SUNNICA ENERGY FARM

EN010106

8.52 Update by the Applicant on Heritage Matters and Substation
Connection

| Version | Date | Status of Version |
|----------------|------------------|--------------------------|
| Rev 00 | 28 November 2022 | Deadline 3A Submission |

Drawing Title
W04 PROPOSED EXTENSION TO ARCHAEOLOGICAL PROTECTION

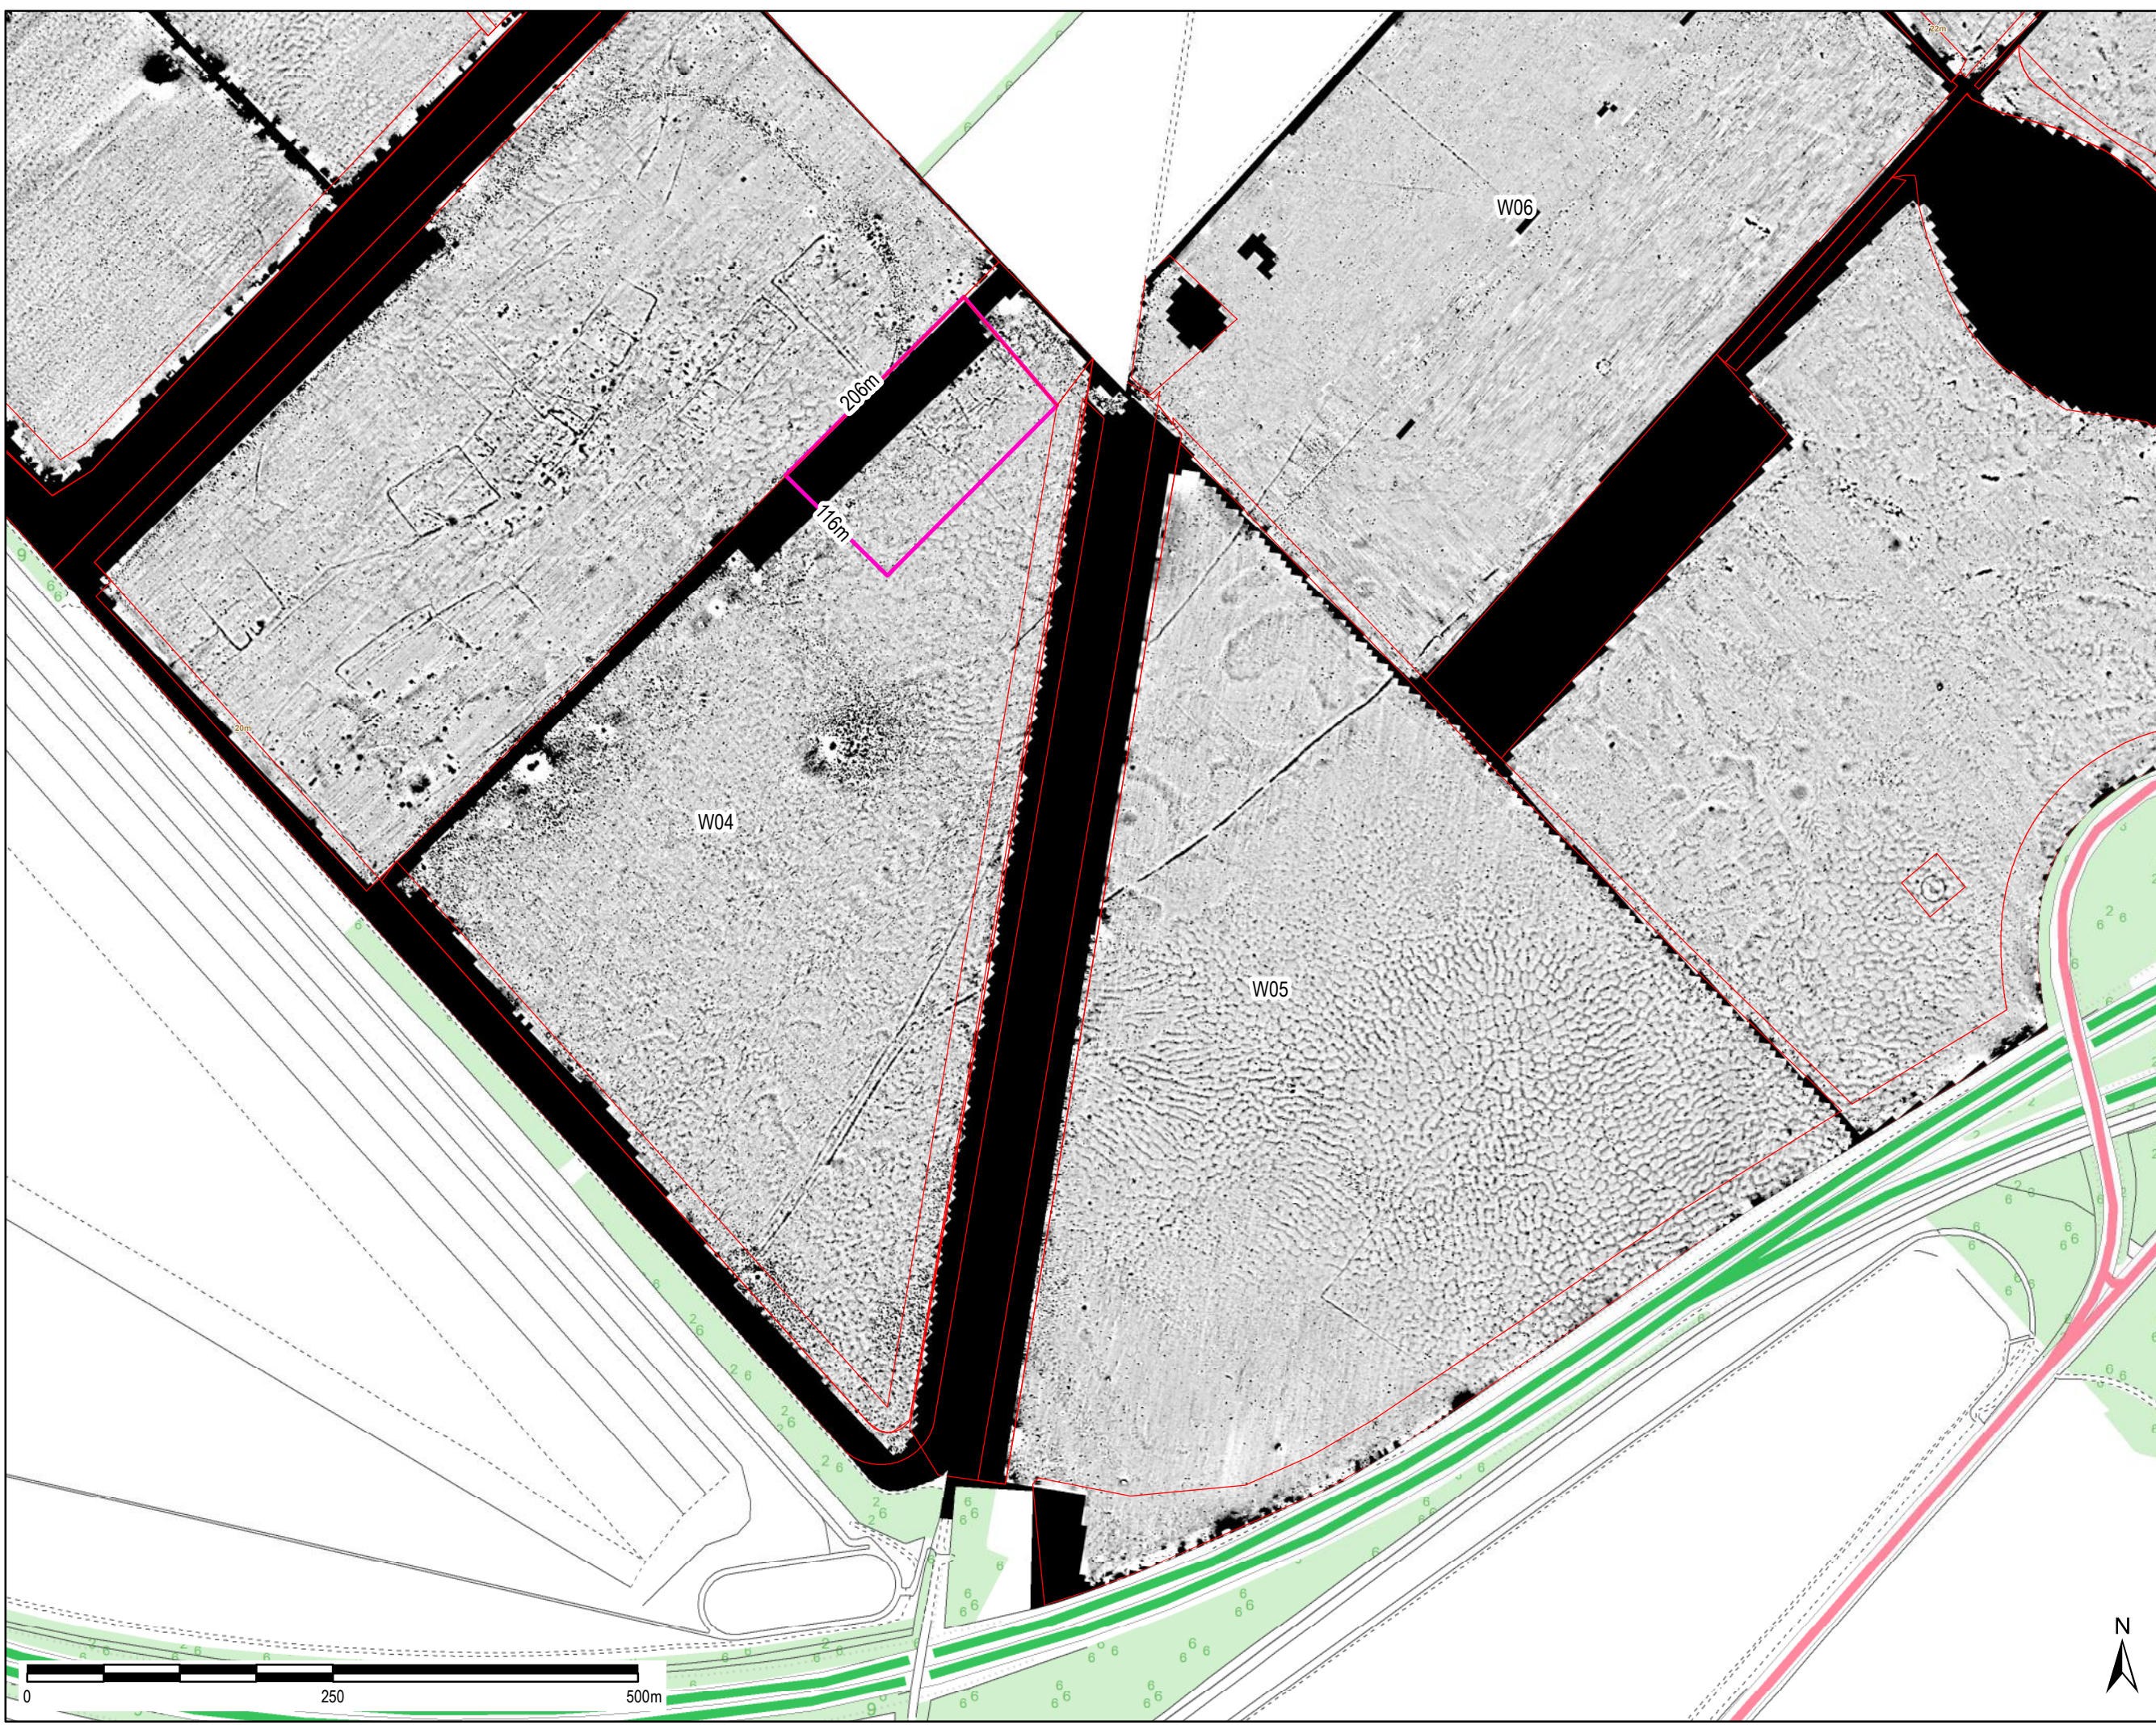
- 5.1.1 The results of geophysical survey in the northern part of W04 indicate an area of concentrated archaeological features that represent an extension to the area already proposed for archaeological preservation to the immediate West of W04. Although it has not been highlighted in the RR or LIR, Cambridgeshire Council Historic Environment Team ("CCHET") have recommended in previous consultation meetings that this area to be omitted from the development.

- 5.1.2 The Applicant is willing to exclude (via changes to the Works Plans and for the purposes of this note appended at Plan C) an area encompassing the concentration of features in the north of W04 as the remains are likely to be associated with settlement features in the area excluded from development to the immediate west. The Applicant agrees that preserving the concentration of settlement features in the north of W04 in situ would be appropriate on archaeological grounds.

- 5.1.3 If this area was to be removed from the Scheme, it would mean the following in respect of the questions asked at paragraph 3.1.14:
- a. the power generation created by the Scheme would be reduced by the total of the area within the extended mitigation area which is approximately 2.39 Ha. Therefore, an estimate of approximately 2.4MWp installed capacity solar PV would be removed from the overall installed capacity of the Scheme.

5.1.4 The management of this additional archaeological protection area in W04 will be included in the HEMP section of an updated Landscape and Ecological Management Plan which will be submitted to the Examination in due course, following the issuing of a brief from CCHET, which will take account of this decision.

5.1.5 It is important to note that there will still be a need for the cable route corridor to traverse along the northern boundary of W04 to the north of the additional area of protection. Mitigation for the resulting archaeological impact will be agreed with CCHET and included in the DAMS.
